L&V Checklist

Landscape and Visual Impact Assessment Checklist for Site Audit – North Point PTW

Inspection Date: 24 June, 2022
Time: 10:15 am

Figure 3	Figure 4	
<p style="text-align: center;">Tree T110 & T109</p> 		
Stonecutters Island PTW	Stonecutters Island PTW

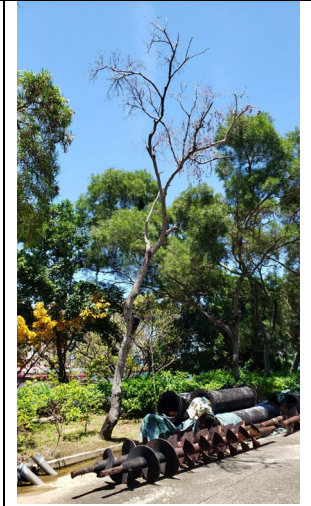
1. Some trees adjacent to trees T110 & T109 (shown in Figure 3) are severely tilted. The Contractor is recommended to carry out remedial action.
2. Some tree branches span over driveway (shown in Figure 3). The Contractor is recommended to carry out close monitoring or tree assessment.

- Vigour of some existing trees (e.g.T110 & T109) are found to be poor. Some adjacent trees are severely tilted. Close monitoring or tree risk assessment may be required.
- Die back of trees is noted. It is recommended that the maintenance party to review the situation and to remove the trees to reduce the safety risk if found to be required.
